Attachment A – List of Affected FSAR Sections

Attachment B - SGTR Figures

Attachment C - FSAR Addendum Markups

CALLAWAY PLANT
FIGURE 15.8-3A
PRESSURIZER AND STEAM GENERATOR (RUPTURED AND INTACT GENERATORS) PRESSURE TRANSIENTS FOR STEAM GENERATOR TUBE RUPTURE EVENT
REV. 16 6/11

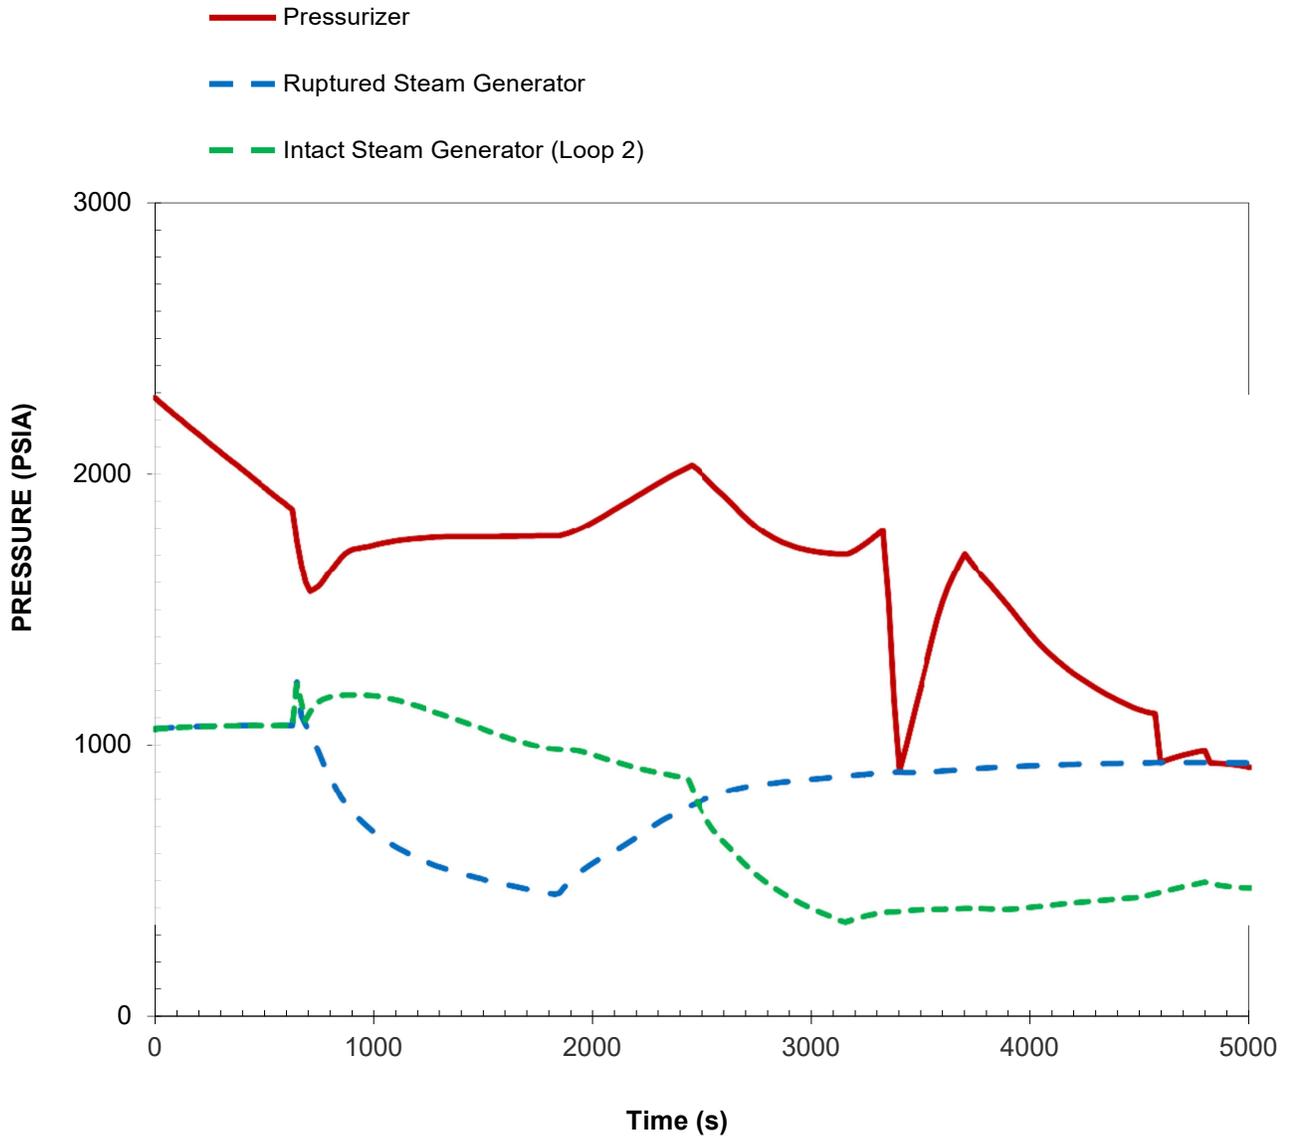
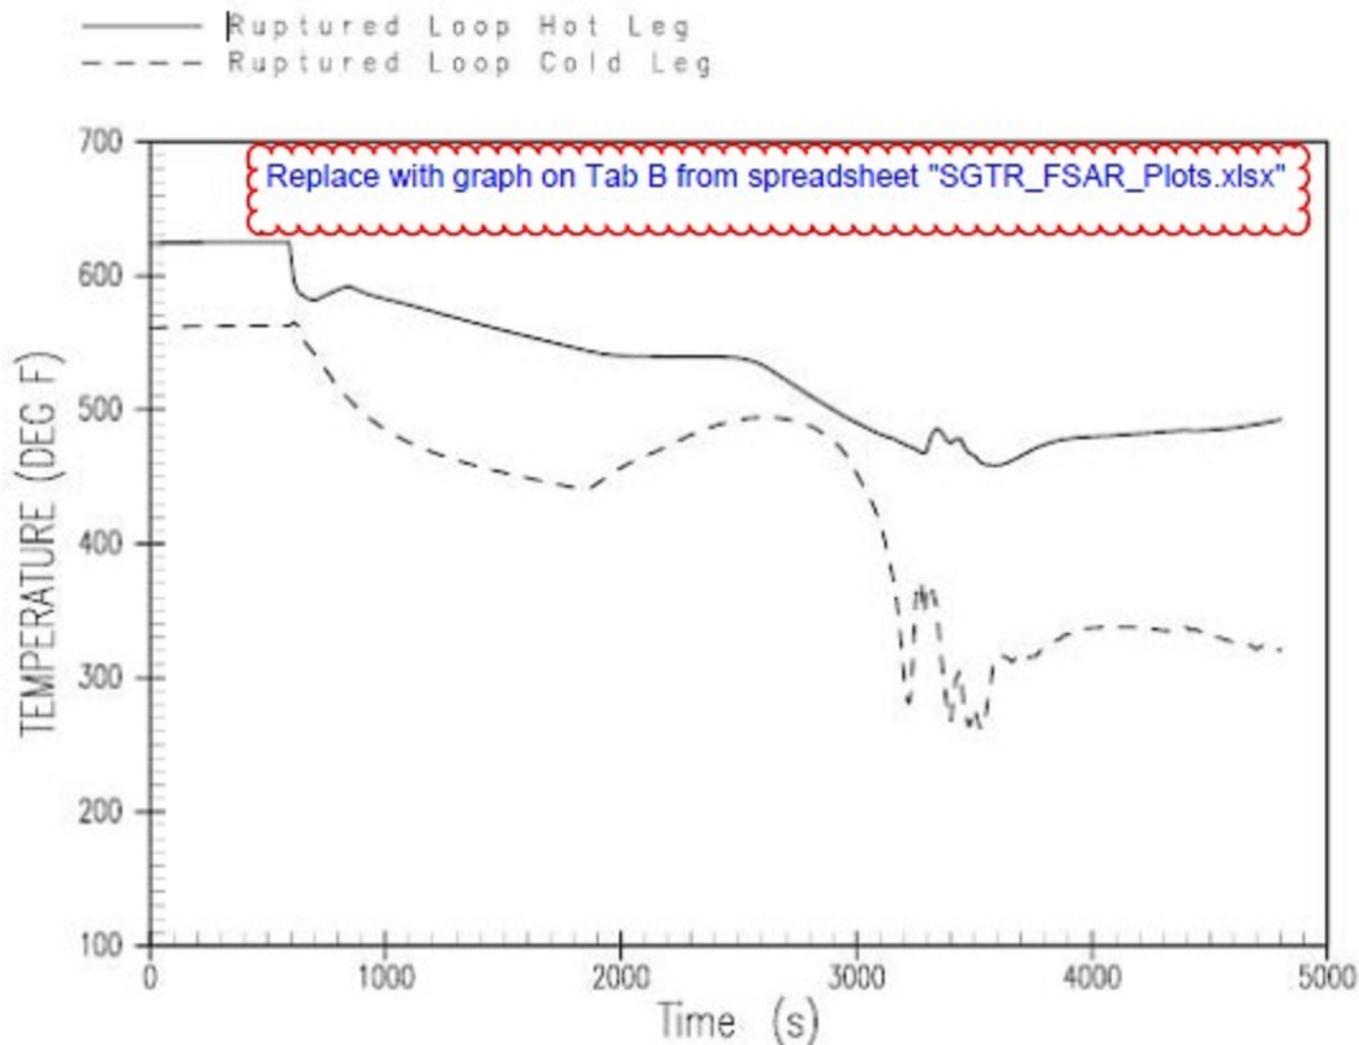
Additional calculations have been performed that conservatively reduce the number of credited ASDs available for the rapid cooldown from three to two. This results in a longer rapid cooldown duration than is shown on this figure. The analyses that use the reduced ASD availability were performed to quantify radiological consequences of the prolonged cooldown. Conservative flowrates and durations were used in the radiological consequence analyses.

Figure 15.6-3a: Replaced with Tab A in spreadsheet "SGTR_FSAR_Plots.xlsx"

FIGURE 16.8-3B

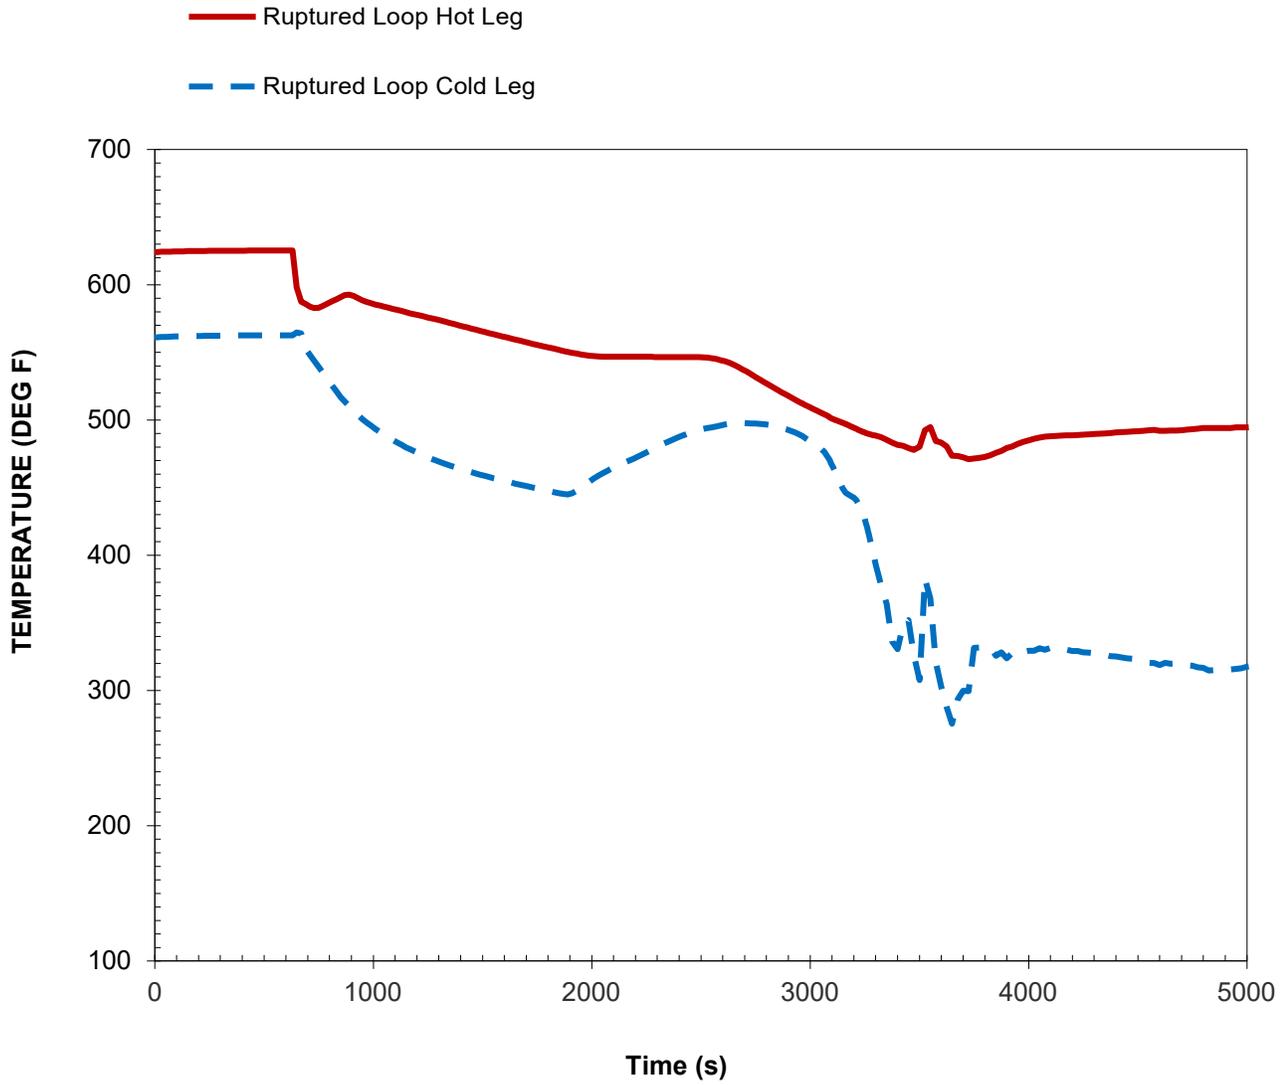
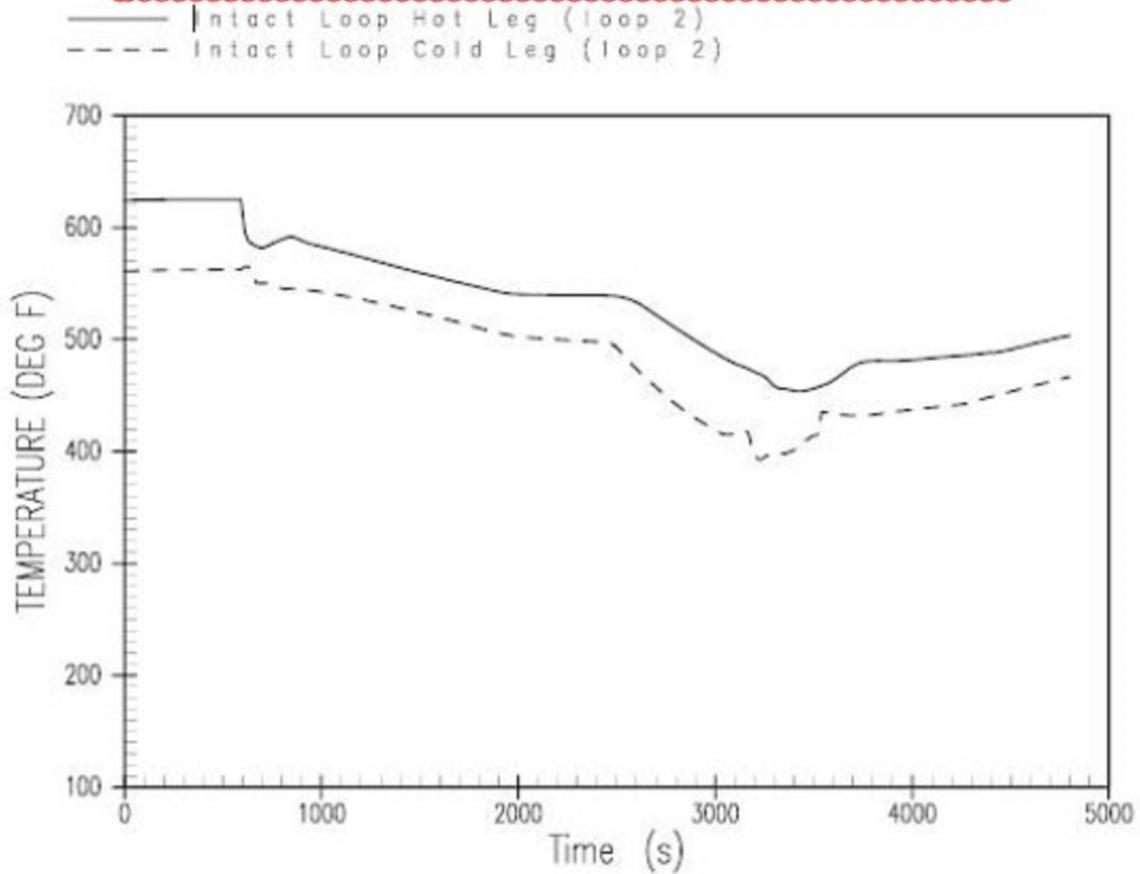
Replace with graph on Tab C from spreadsheet "SGTR_FSAR_Plots.xlsx"

Figure 15.6-3b: Replaced with Tab B in spreadsheet "SGTR_FSAR_Plots.xlsx"

CALLAWAY PLANT
FIGURE 15.8-3C
REACTOR COOLANT SYSTEM TEMPERATURE
(INTACT LOOPS) TRANSIENT FOR STEAM
GENERATOR TUBE RUPTURE EVENT
REV. 10 6/11

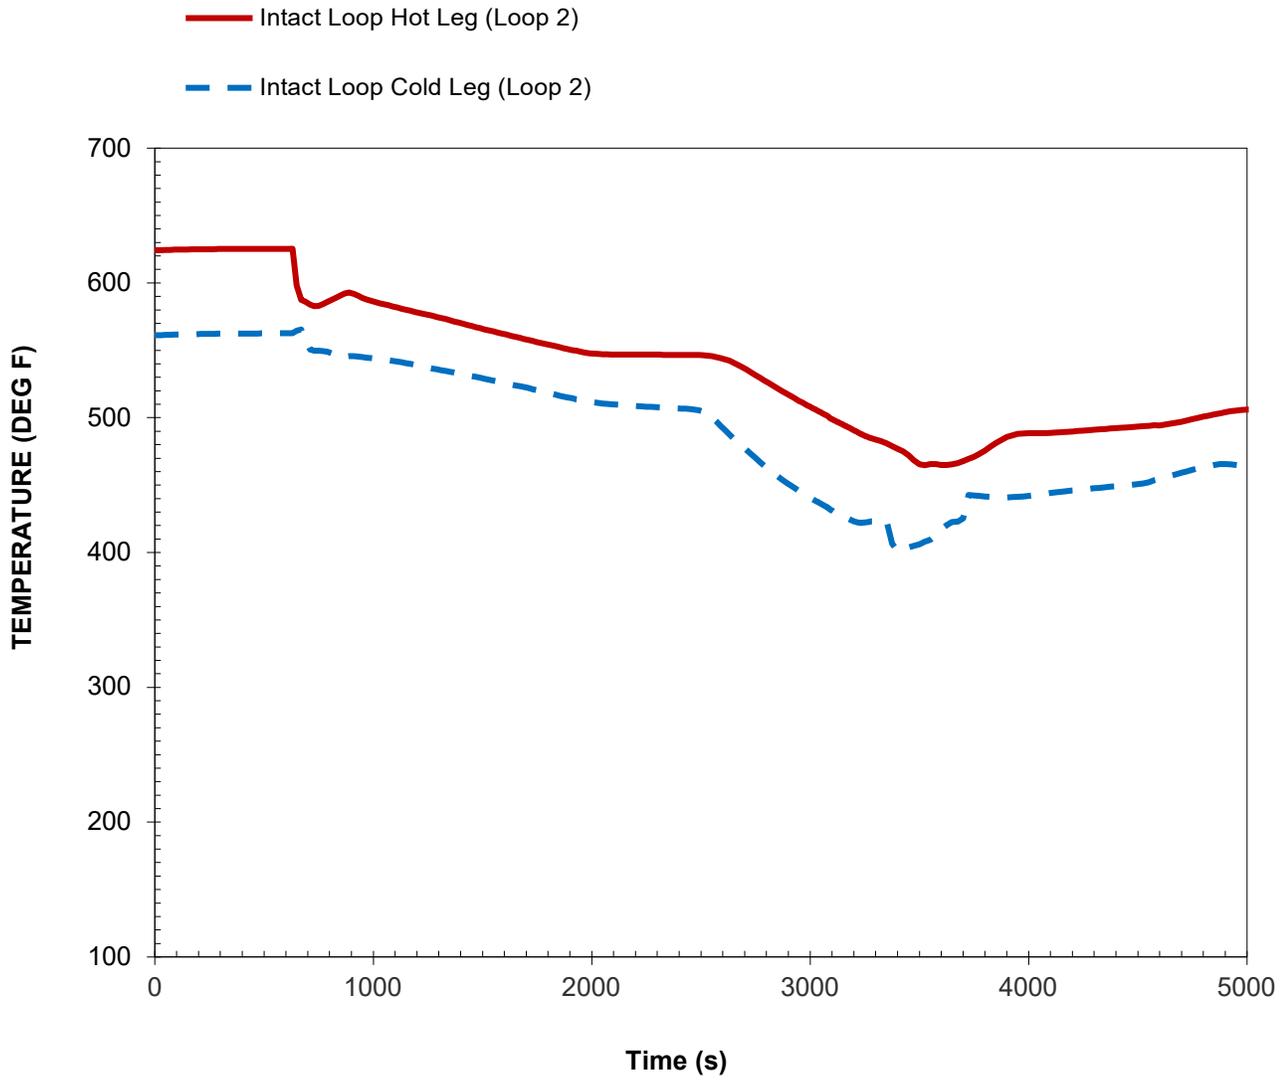
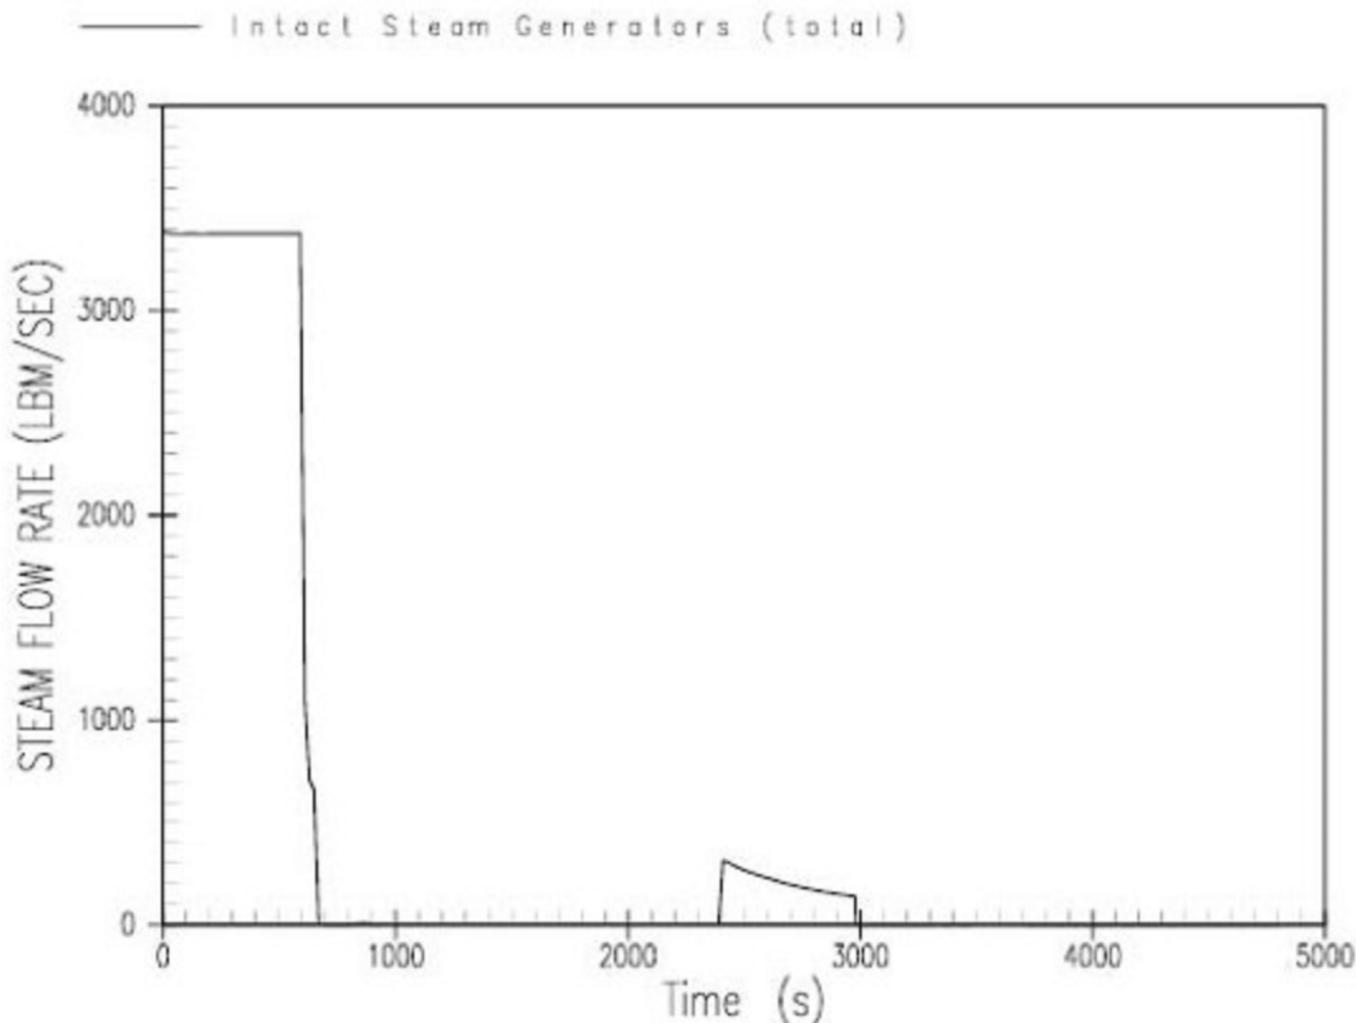
Replace with graph on Tab D from spreadsheet "SGTR_FSAR_Plots.xlsx"

Figure 15.6-3c: Replaced with Tab C in spreadsheet "SGTR_FSAR_Plots.xlsx"

CALLAWAY PLANT
FIGURE 15.6-33A
PRESSURIZER AND STEAM GENERATOR (RUPTURED AND INTACT GENERATORS) PRESSURE TRANSIENTS FOR SGTR EVENT WITH OVERFILL
REV. 10 6/11

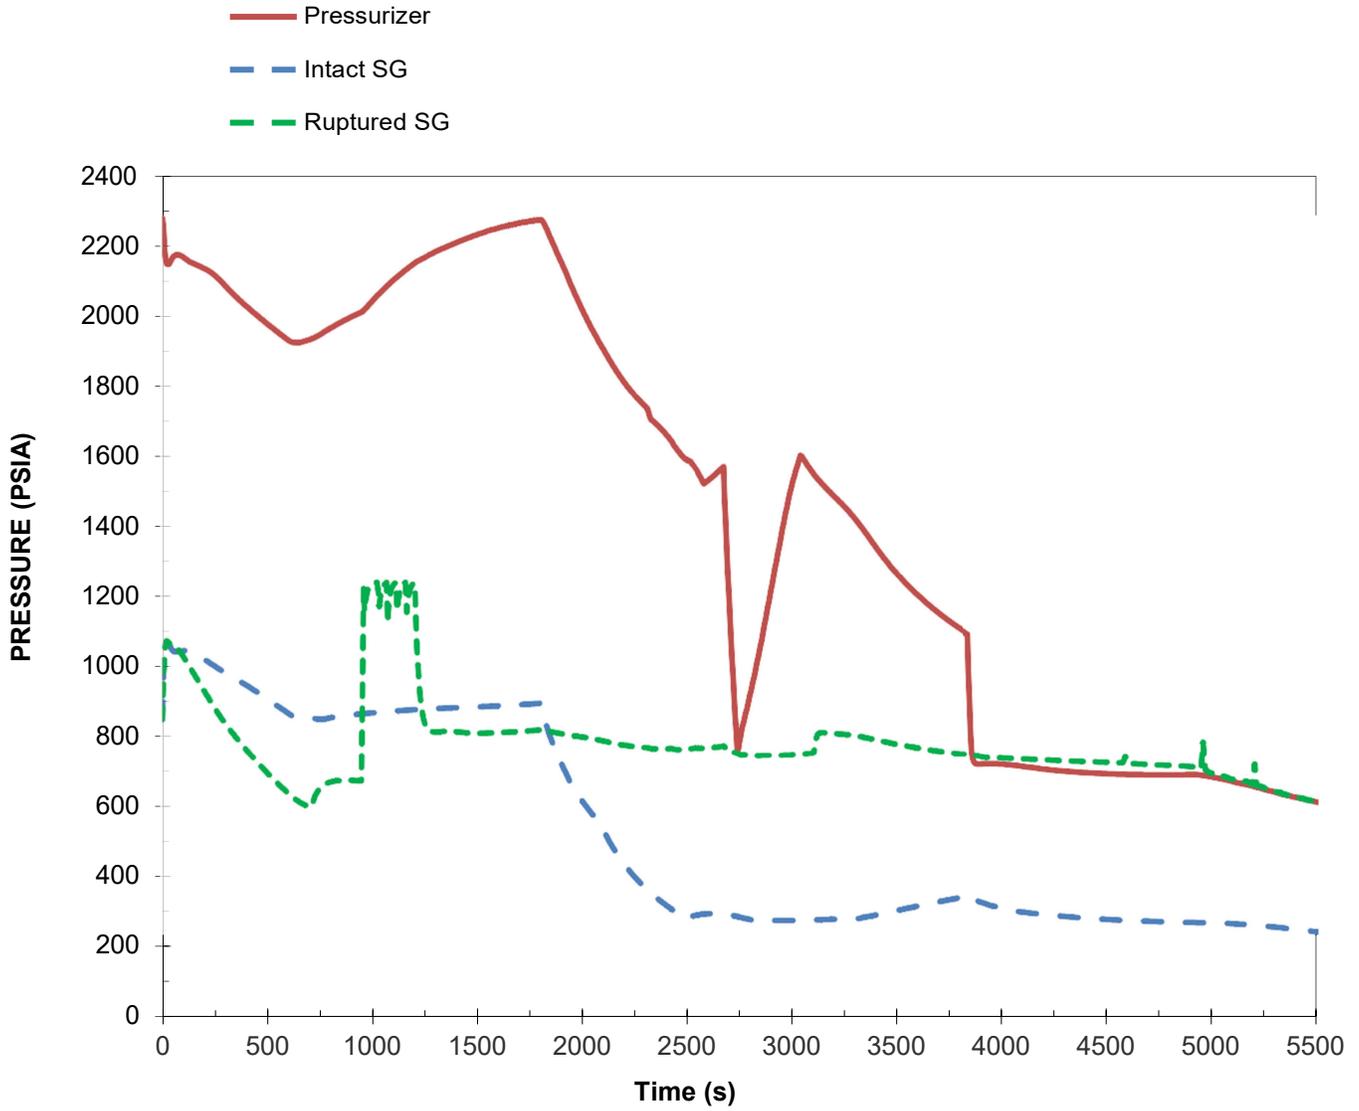
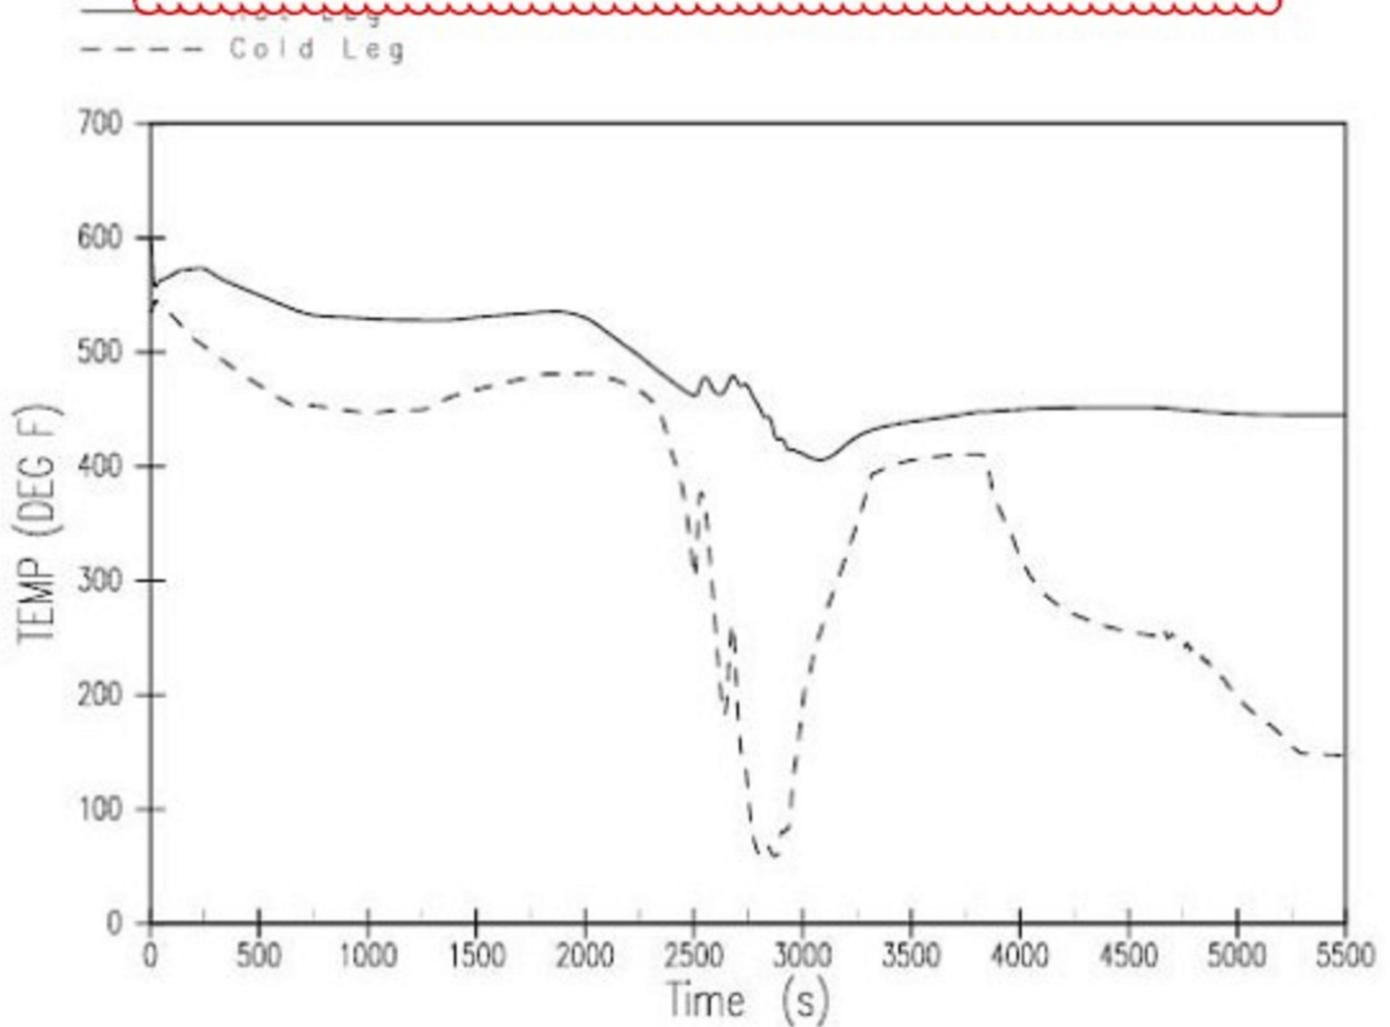
Additional calculations have been performed that conservatively reduce the number of credited ASDs available for the rapid cooldown from three to two. This results in a longer rapid cooldown duration than is shown on this figure. The analyses that use the reduced ASD availability were performed to quantify radiological consequences of the prolonged cooldown. Conservative flowrates and durations were used in the radiological consequence analysis.

Replace with graph on Tab B from spreadsheet "Overfill_FSAR_Plots.xlsx"

Figure 15.6-33a: Replaced with Tab A in spreadsheet "Overfill_FSAR_Plots.xlsx"
